Elaine Tata, Hearing Officer
State of Connecticut Department of Environmental Protection
79 Elm Street
Hartford, CT 06106
Re: Application 200103104

I am writing to express my concerns regarding the accuracy of many of the exhibits submitted by the Applicant in this matter.

Attachment CG-1
 Rev.0 3-16-02

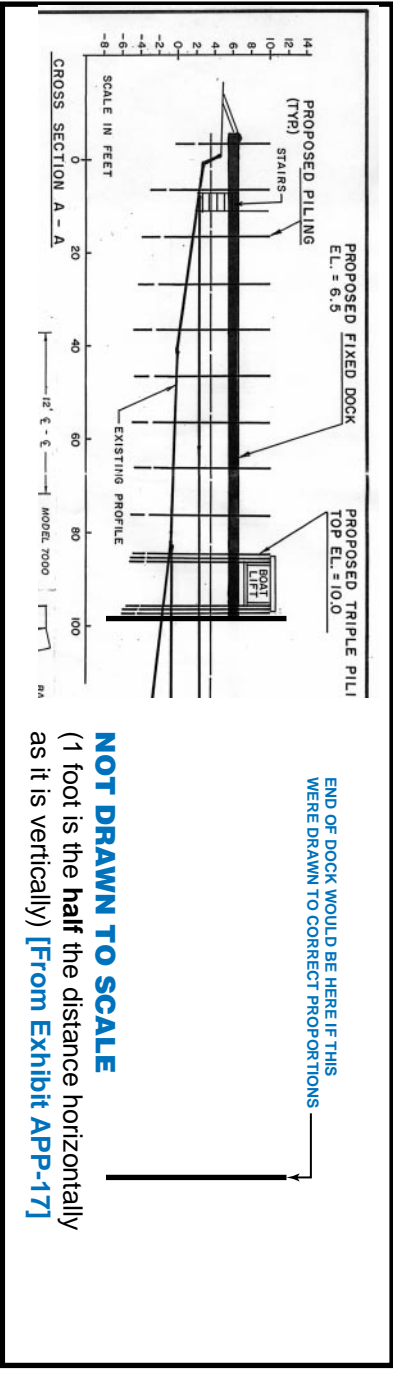
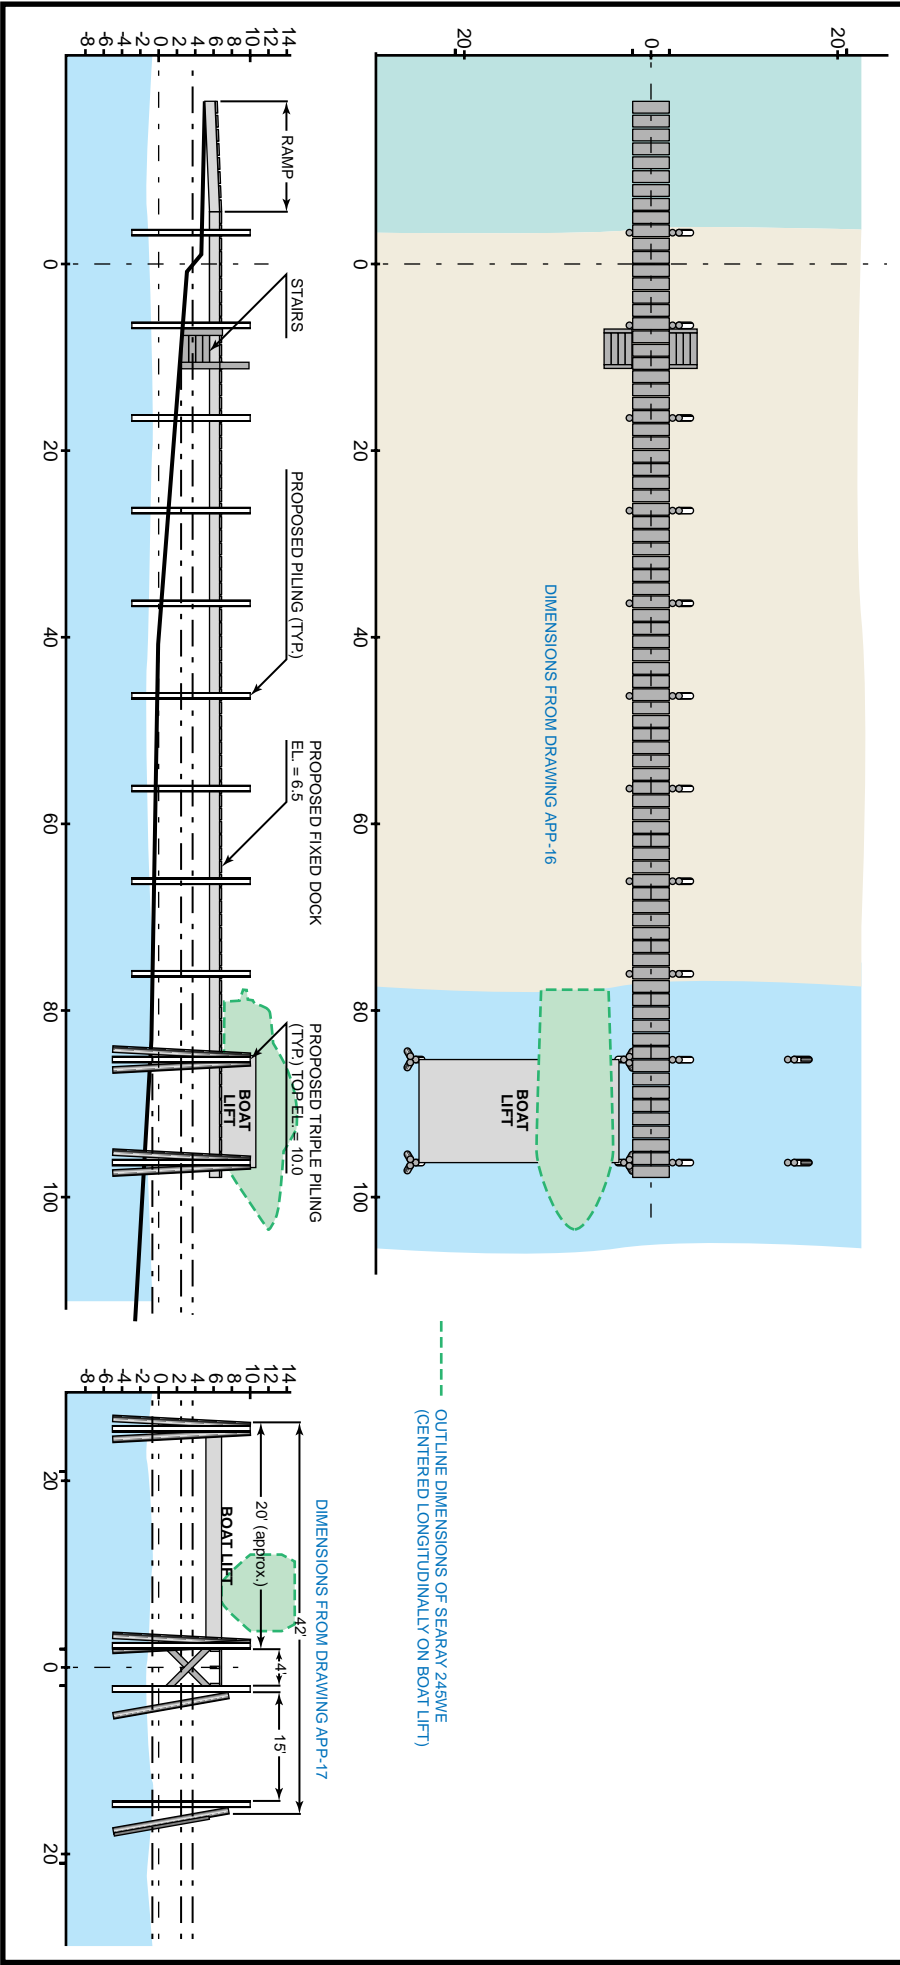
My first concern is the lack of accuracy in the drawing marked as Exhibit APP-17. The cross-section view of this drawing was **not** drawn proportionally, and the effect of the misproportioning was to make the dock appear to be **half** as long as would in fact be if it were drawn in conformance to standard engineering practice (see *attachment CG-1* for a drawing with correct proportions).

Exhibit APP-16 is inaccurately drawn as well; the 42-foot width of the total dock structure is not, in fact, centered on the dock itself as the drawing indicates. See attachment CG-1 for a corrected view.

Attachment CG-4

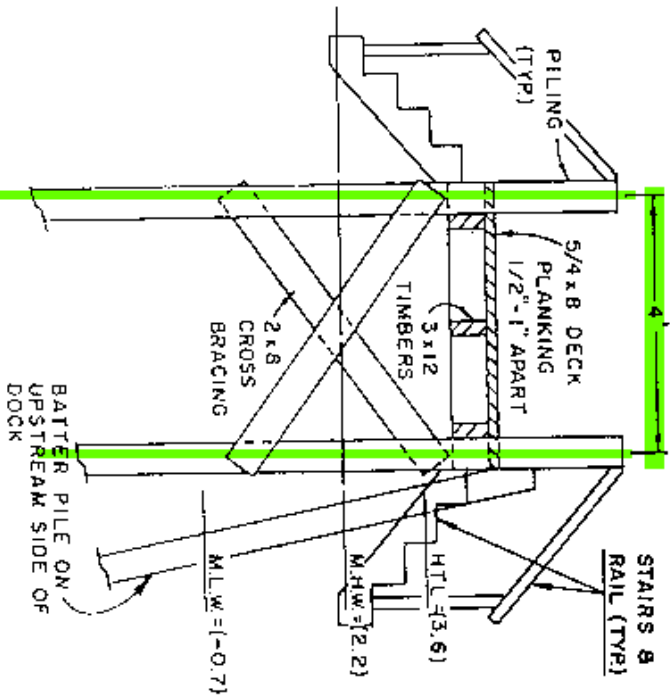
Other drawing inaccuracies also call the veracity of the applicant's engineer into doubt. The drawing of the end view of the dock (reproduced as attachment CG-4) calls out the 4-foot width of the dock as being measured from the centerline of the downstream pilings to the centerline of the upstream pilings.

This would indicate that:

- 1) The actual width of the dock deck would be greater than four feet (as shown by the crosshatched area on the drawing); and
- 2) The pilings would be "notched into" the deck of the docks, rather than the deck being entirely between the pilings, as is shown on Attachment CG-1.

I believe that the actual intention is to place the pilings tangent to the deck of the dock, resulting in an effective width of roughly six feet (pilings in addition to the four-foot deck width), and that the drawing reproduced as attachment CG-4 deliberately attempts to conceal this fact.
